# PLATTE SELF STORAGE

## GRADING AND EROSION CONTROL PLAN

### OVERVIEW SHEET

AUGUST 2024

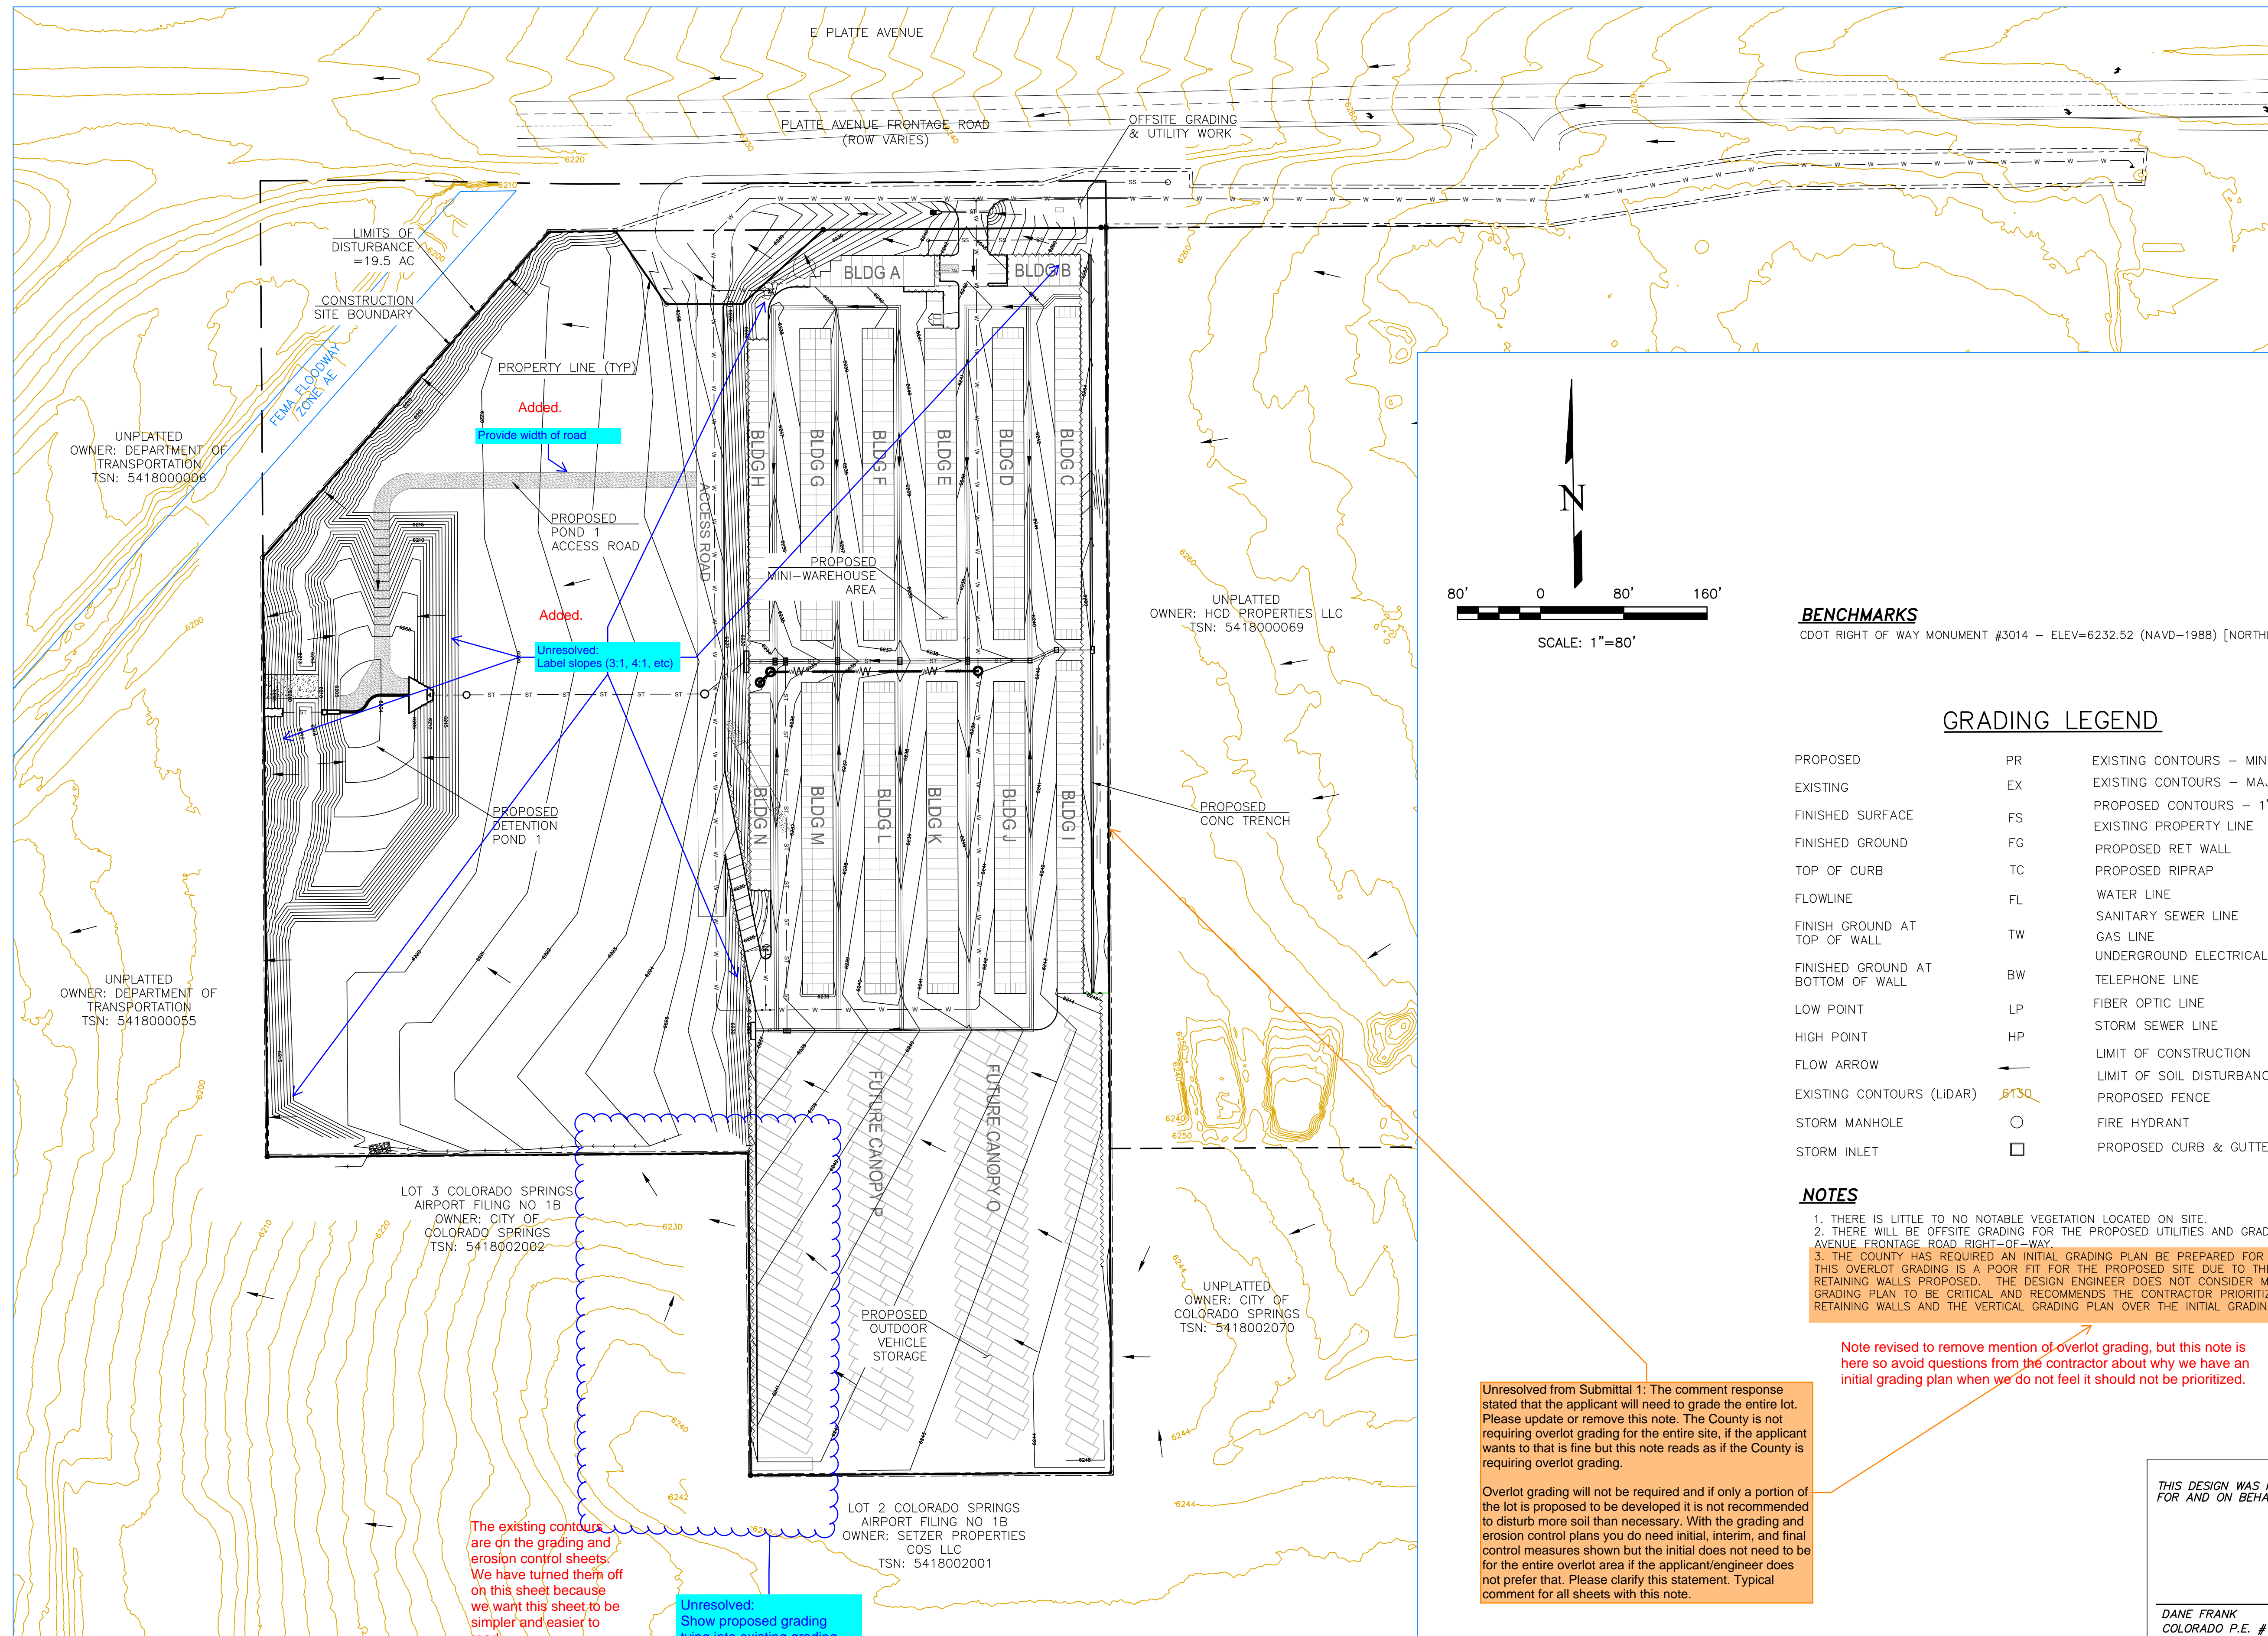
Unresolved from Submittal 1: The comment response stated that the applicant will need to grade the entire lot. Please update or remove this note. The County is not requiring overlot grading for the entire site, if the applicant wants to that is fine but this note reads as if the County is requiring overlot grading.

Overlot grading will not be required and if only a portion of the lot is proposed to be developed it is not recommended to disturb more soil than necessary. With the grading and erosion control plans you do need initial, interim, and final control measures shown but the initial does not need to be for the entire overlot area if the applicant/engineer does not prefer that. Please clarify this statement. Typical comment for all sheets with this note.

Note revised to remove mention of overlot grading, but this note is here so avoid questions from the contractor about why we have an initial grading plan when we do not feel it should not be prioritized.

**PLATTE SELF STORAGE**  
GRADING AND EROSION CONTROL PLAN  
INITIAL - NORTH SIDE

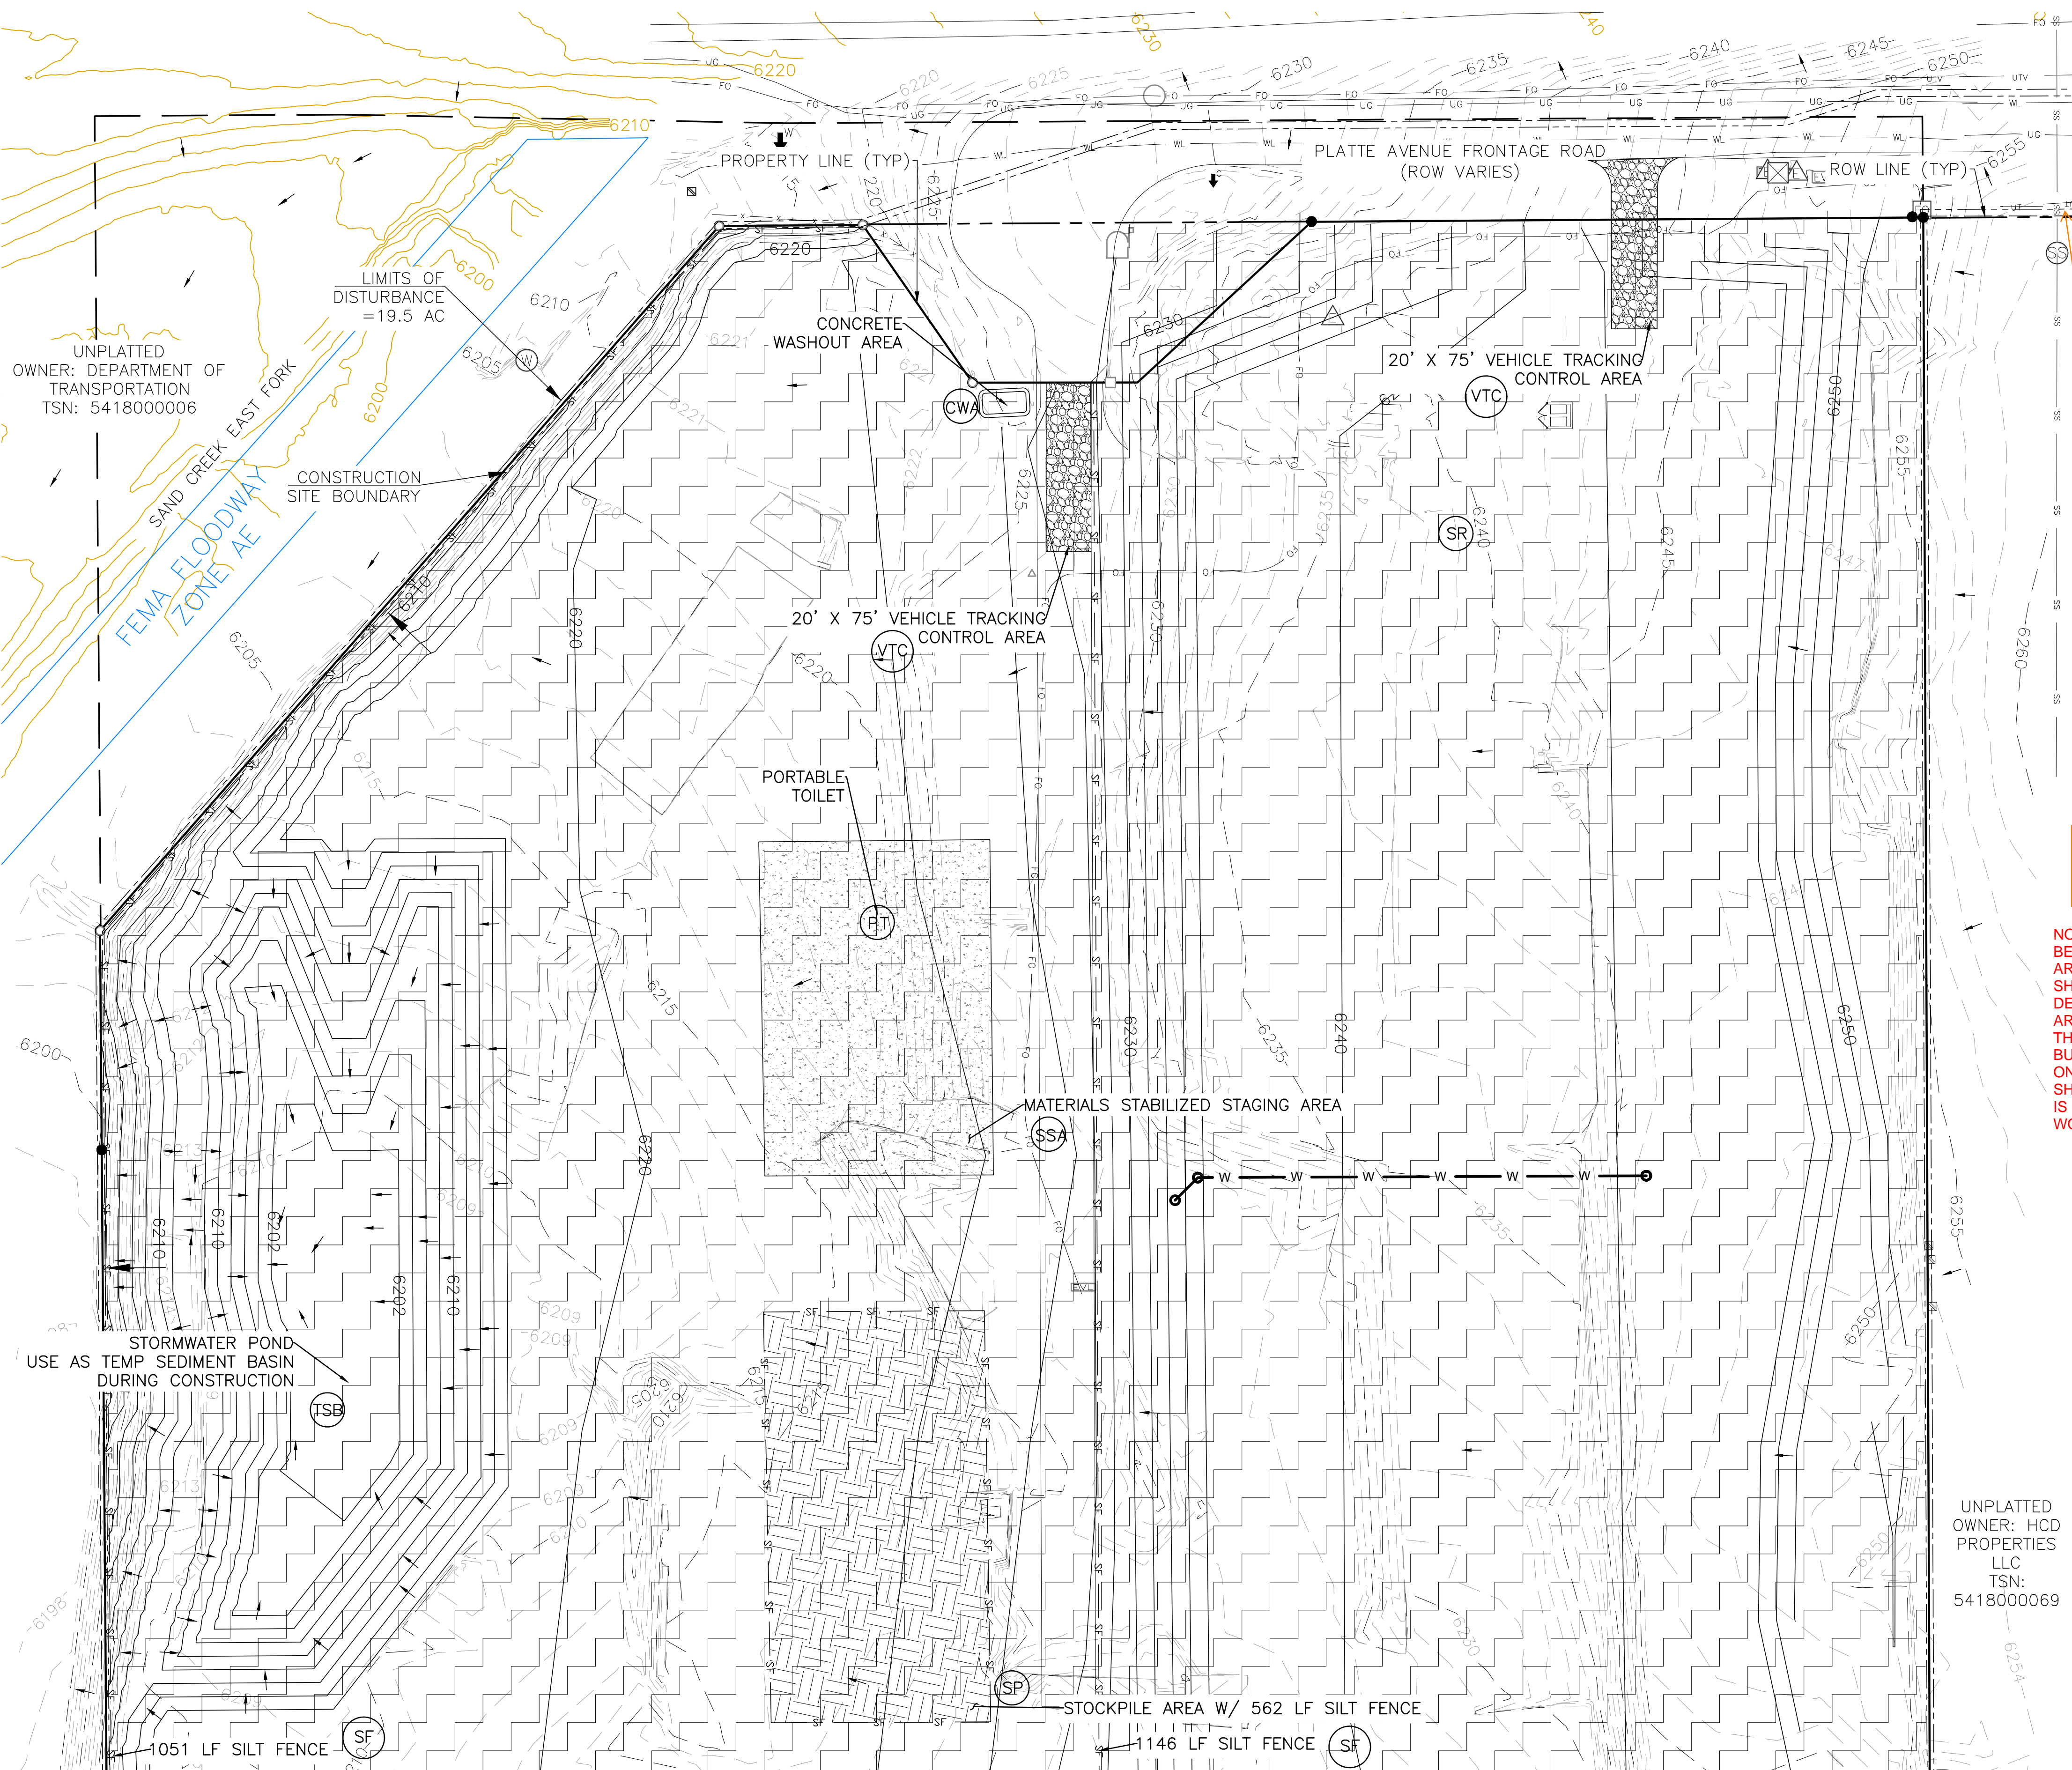
Please include full limits of construction within the view, it appears to extend further to the east.

NO GRADING IS BEING DONE IN THIS AREA THAT ISN'T SHOWN ON THE DETAIL SHEETS. THIS AREA IS SHOWN ON THE OVERVIEW PLAN, BUT IS NOT SHOWN ON THESE DETAIL SHEETS BECAUSE IT IS ONLY UTILITY WORK.

**PLATTE SELF STORAGE**  
GRADING AND EROSION CONTROL PLAN  
INTERIM EROSION CONTROL PLAN - NORTH SIDE

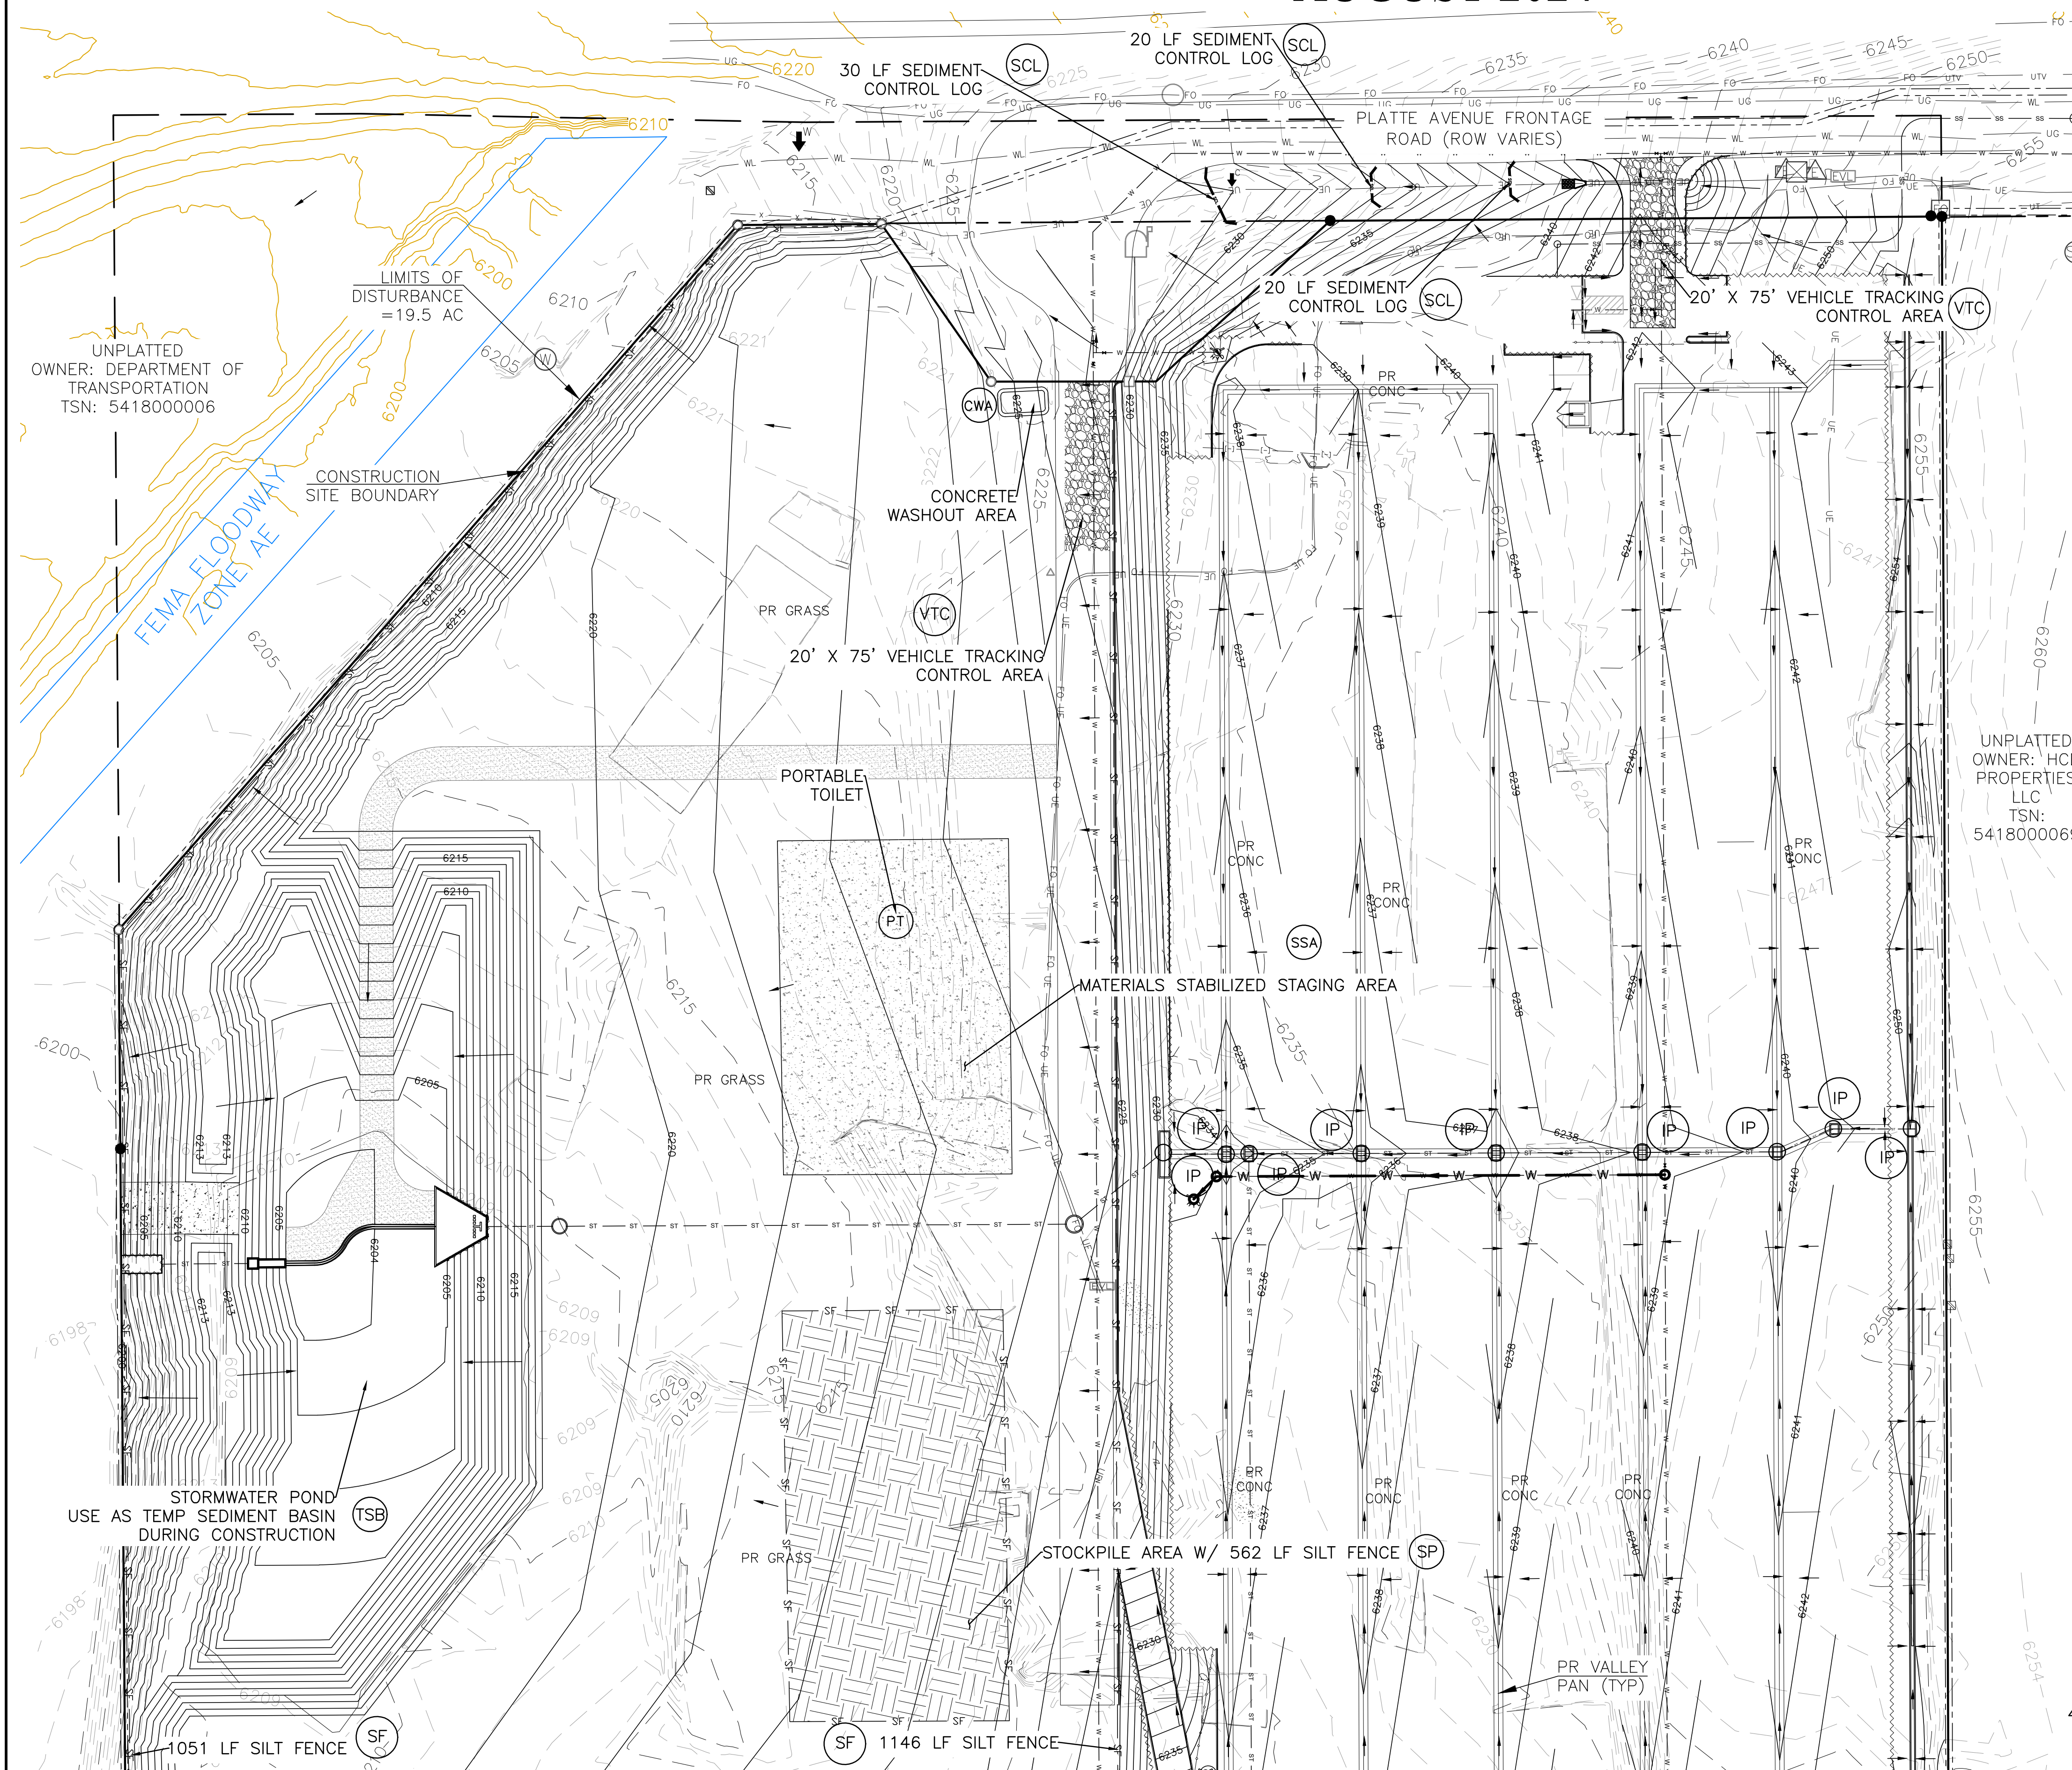
**Unresolved:**  
Show cut/fill limits

**THE CUT/FILL LIMITS ARE SHOWN ON THE FINAL VERTICAL EROSION CONTROL PLAN SHEETS.**
